COLUSA COUNTY Airport Advisory Committee SPECIAL MEETING AGENDA

August 12, 2021

Request For Airport Advisory Committee

SUBJECT: Golden Roots Nursery (Ranveer Tumber) Greenhouse (Hoop Houses) Project

1"=200'

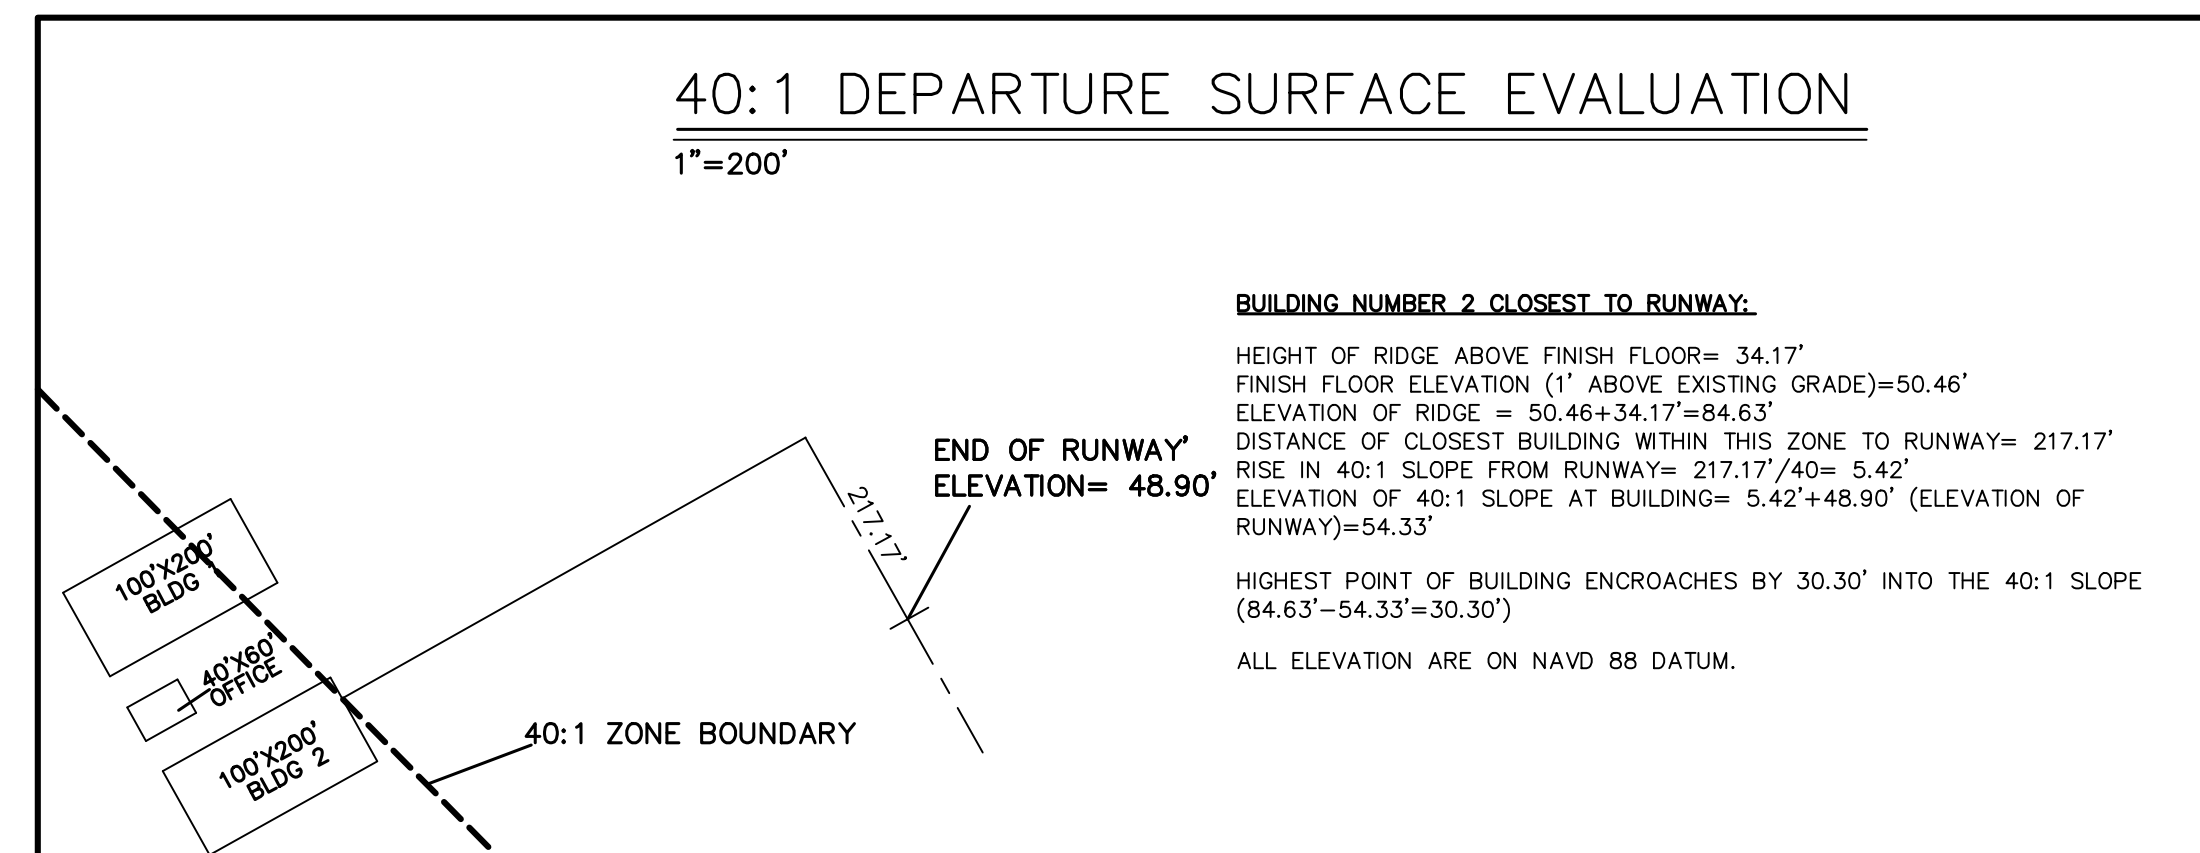
Exhibit "B" shows that the subject site is located in the ALUCP's B1 and C1 Compatibility Zones. As shown in Exhibit "C" (Site and Building Plans), the industrial buildings would be located on the westerly half of the parcel in Zone C1 and the outdoor storage and truck parking would be located on the easterly half of the parcel in Zone B1. The proposed use within the buildings would be considered a "Light Industrial - Low Intensity" use and it is a permitted use in the C1 Zone. Examples of Light Industrial - Low Intensity uses include wood product facilities with a person density of less than 350 sq.ft. per person and does not include the storage of hazardous materials. The proposed use meets these criteria. The proposed use would have outdoor storage in the B1 Zone which is also permitted use, provided an airspace obstruction does not occur (the airspace discussion follows under the height section).

Given the degree of the building encroachments into the various regulated height elevations, staff believes that the information from the FAA's hazard determination should be considered prior to a formal building height consistency determination being made. The Commission could provide an initial consistency determination for issues where the necessary information has been provided that allows for issues to be fully analyzed. However, for issues such as building height where a critical piece of information is not yet available, staff does not believe a formal determination either for or against can be made with any degree of certainty.

7. The property is located within the Airport's Critical Airspace Protection Zone (ALUCP Map 3B, Airspace Protection Surfaces). Project proponents have submitted conceptual plans for two buildings in the easterly half of the property to the FAA for a hazard identification study. The results of the conceptual FAA Aeronautical Study No. 2021-AWP-2877-0E and Aeronautical Study No. 2021-A WP-2883-0E is that objects that exceed a height as little as three feet could penetrate an Airspace Protection Zone.

Exhibit "C"

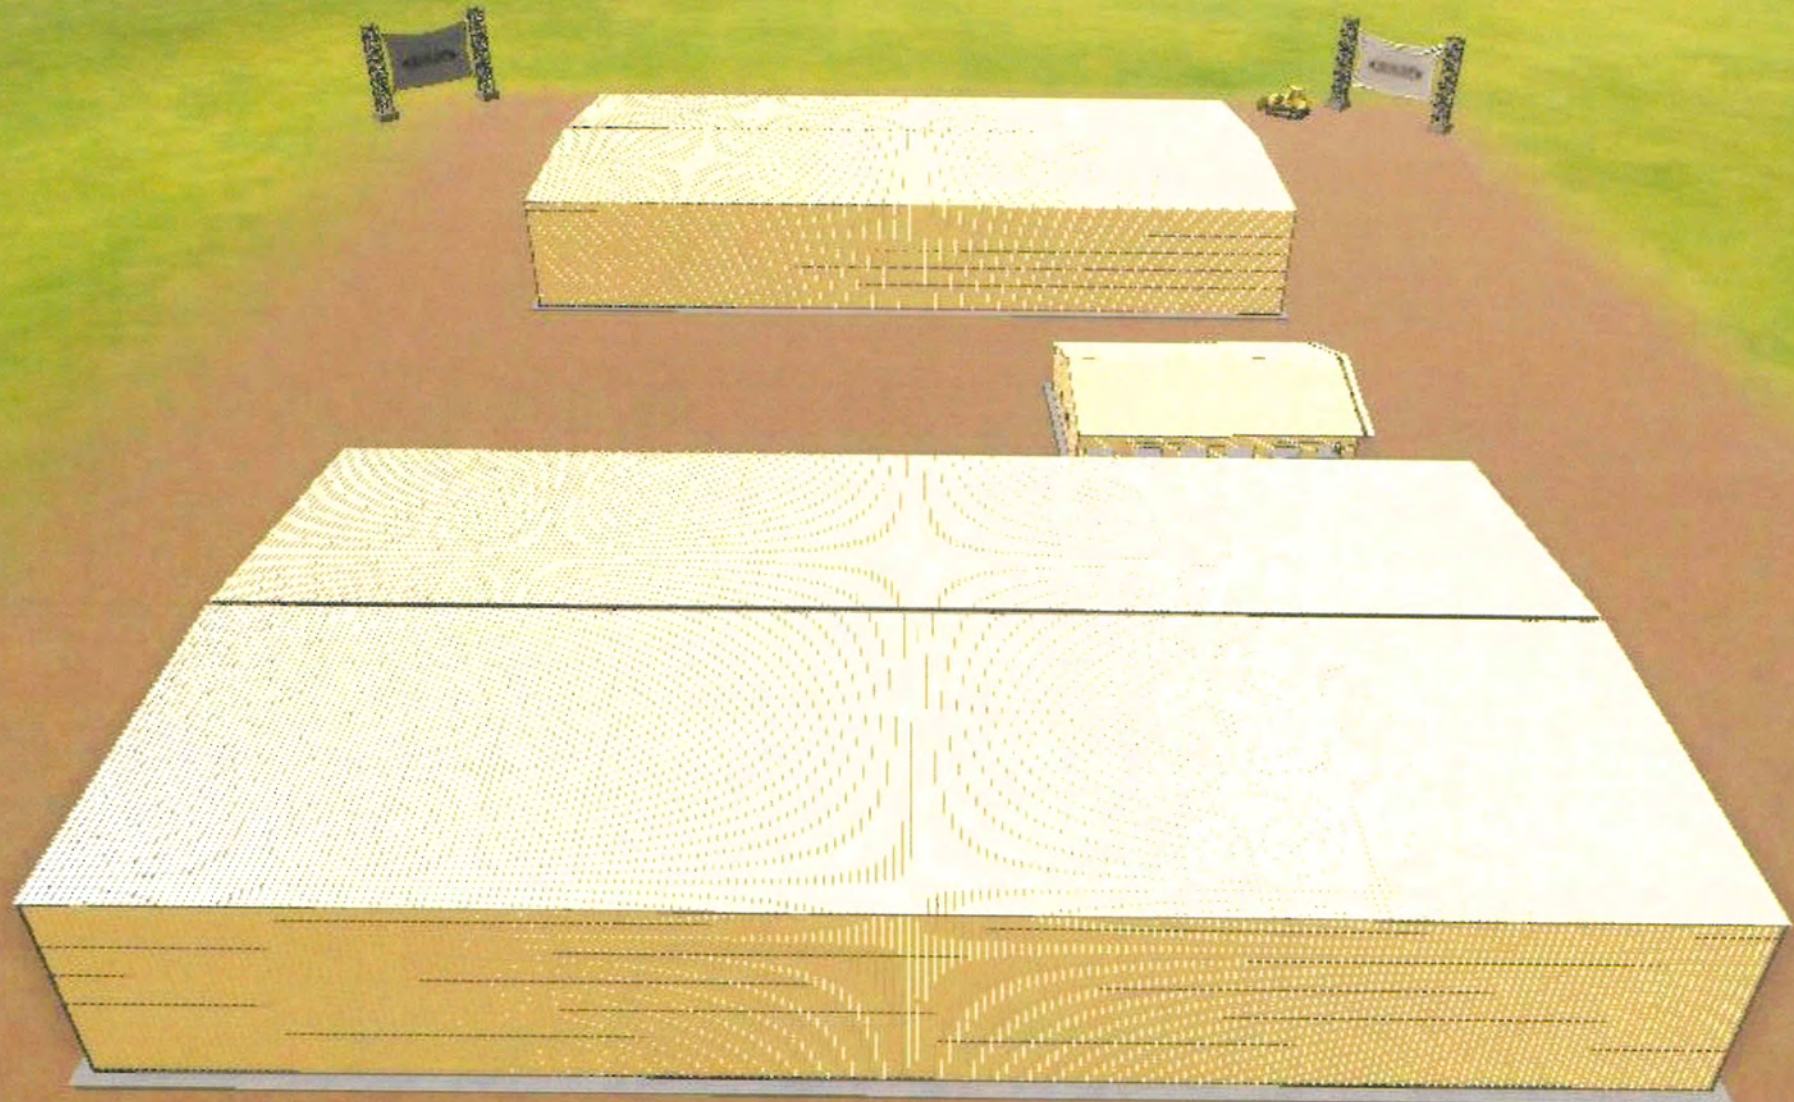
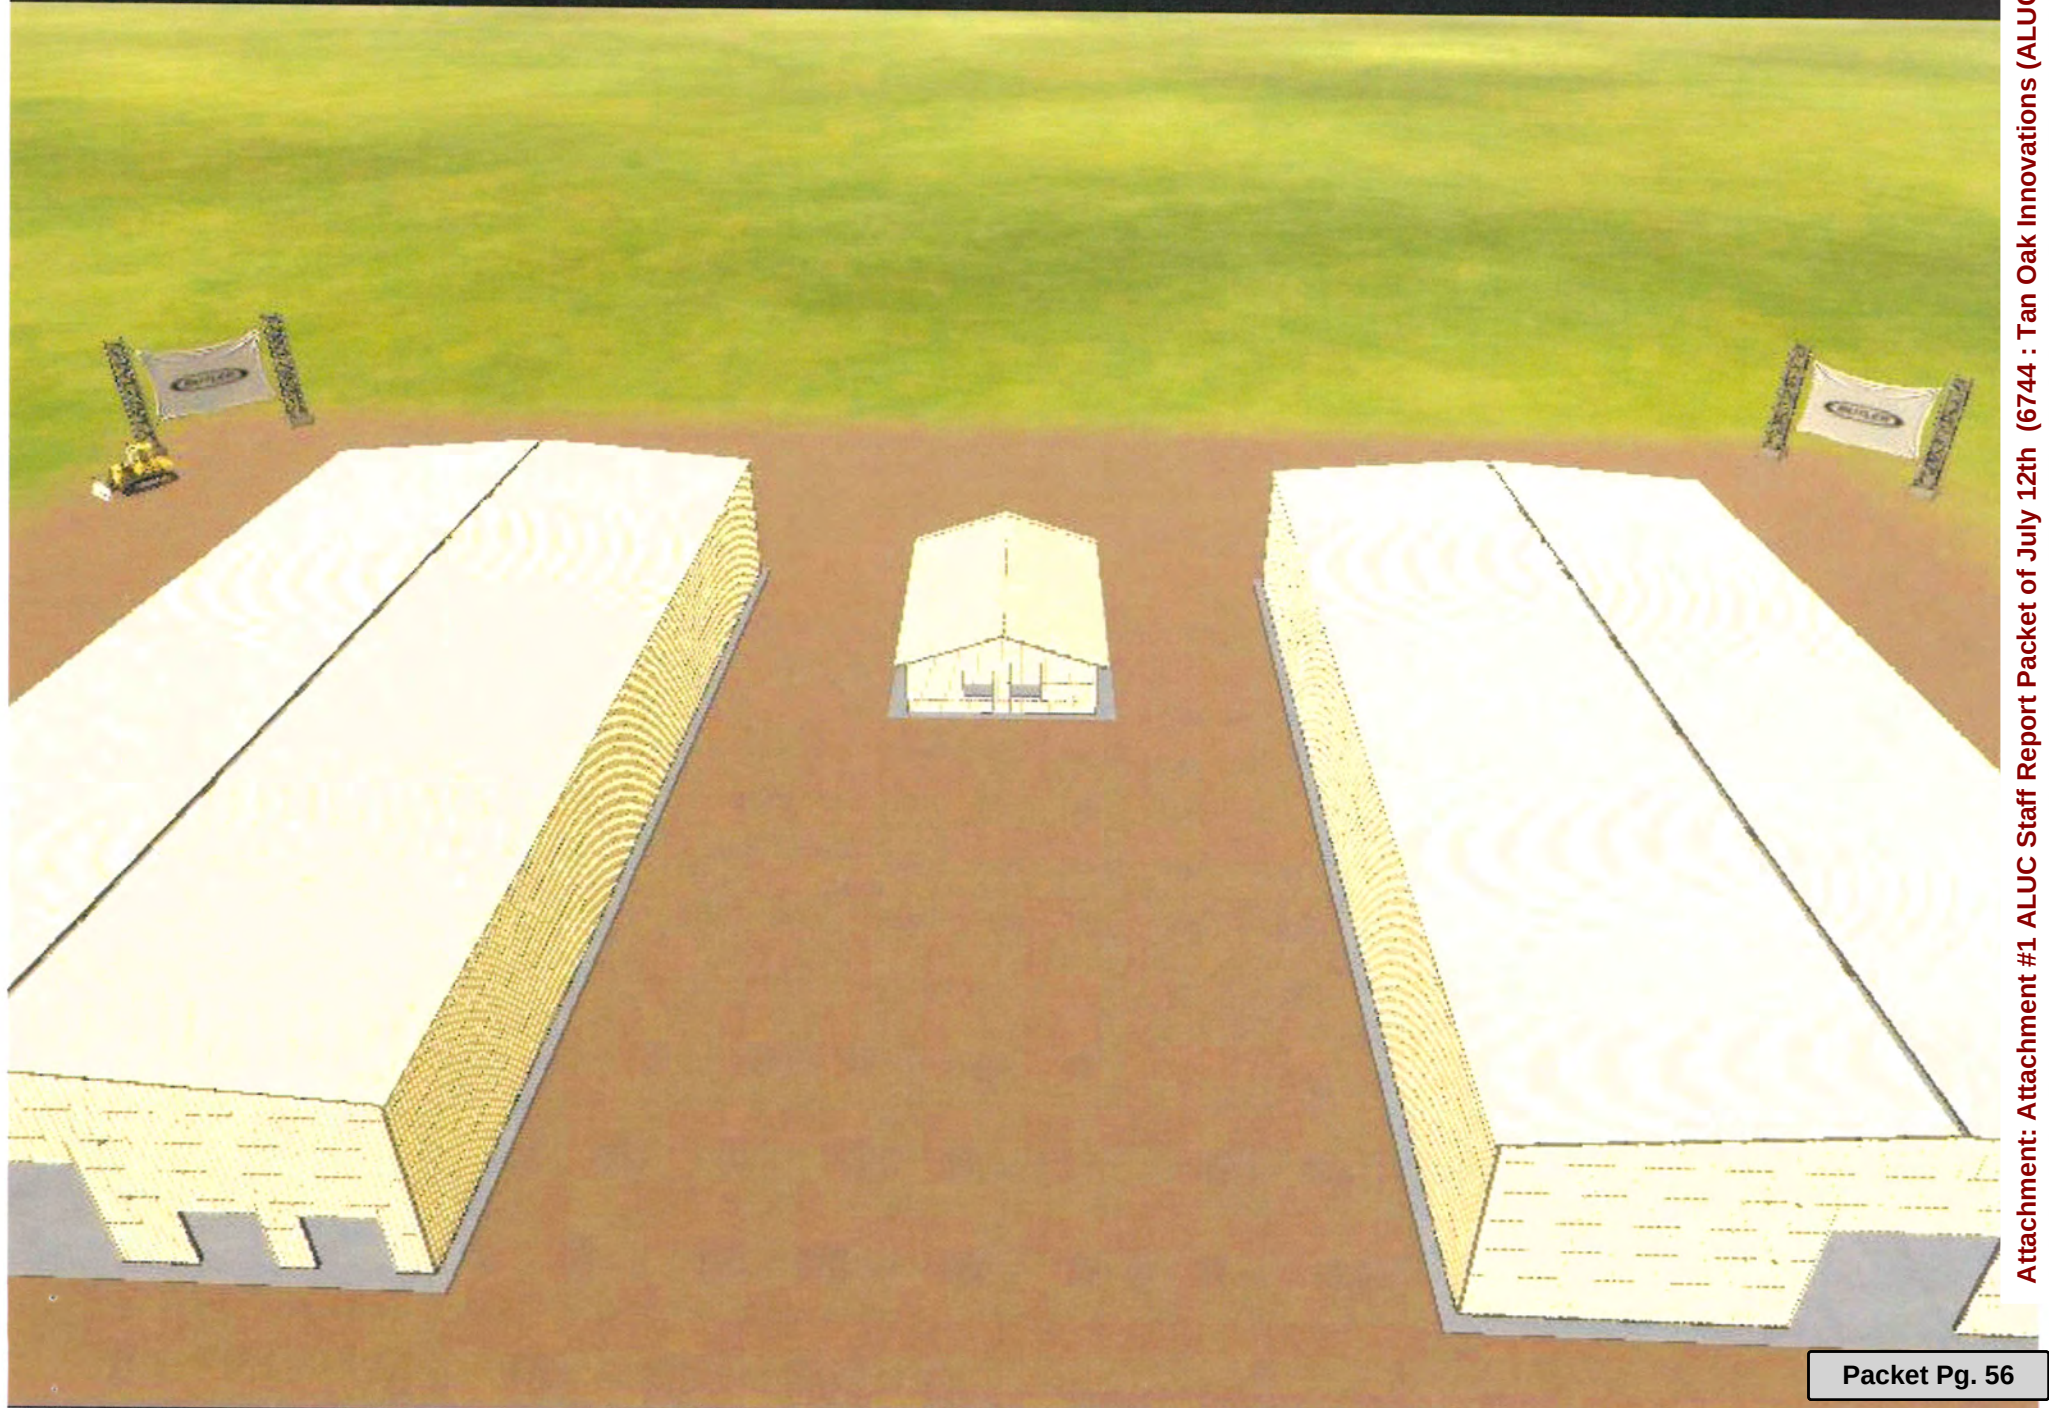
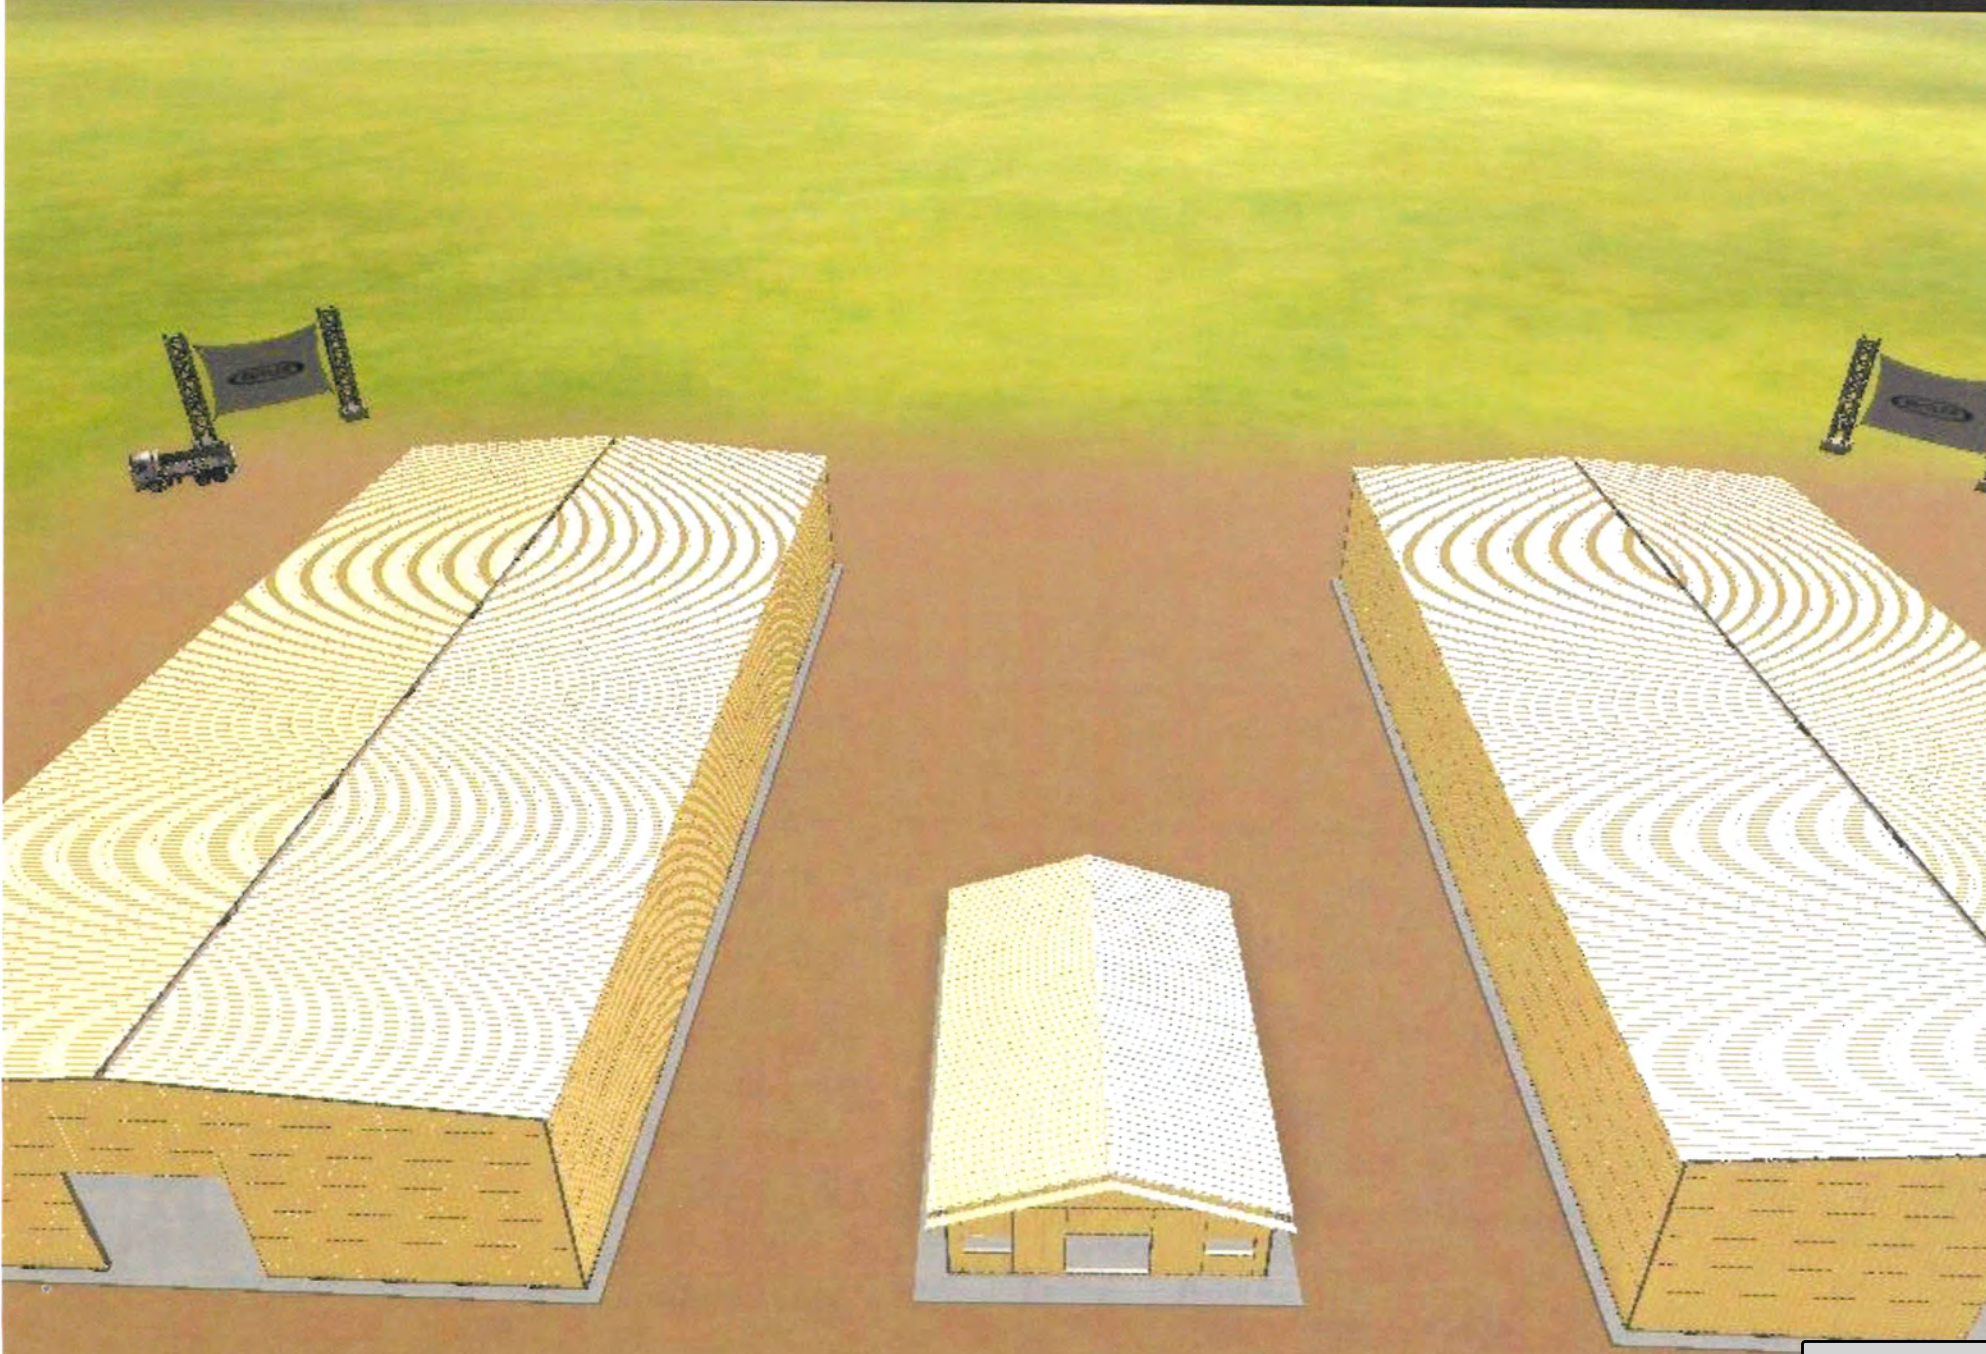
The elevations of the buildings do not show any exterior lighting. In addition, outdoor activity at night would necessitate additional parking lot/storage area lights which have not been shown. Staff believe that this is a minor issue that can be resolved with the requirement that all exterior lighting be shielded and pointed downwards to prevent off-site glare impacts. Any formal consistency finding can include this requirement.

1. The installation of high-intensity and/or unshielded exterior building or other outside lighting could create a negative impact to night-time aircraft flight operations.
2. Any exterior lighting that is installed in conjunction with the proposed development shall be at the minimum intensity level to provide the necessary illumination, shall be shielded to prevent off-site glare impacts, and shall be directed downward to focus the light on the ground.
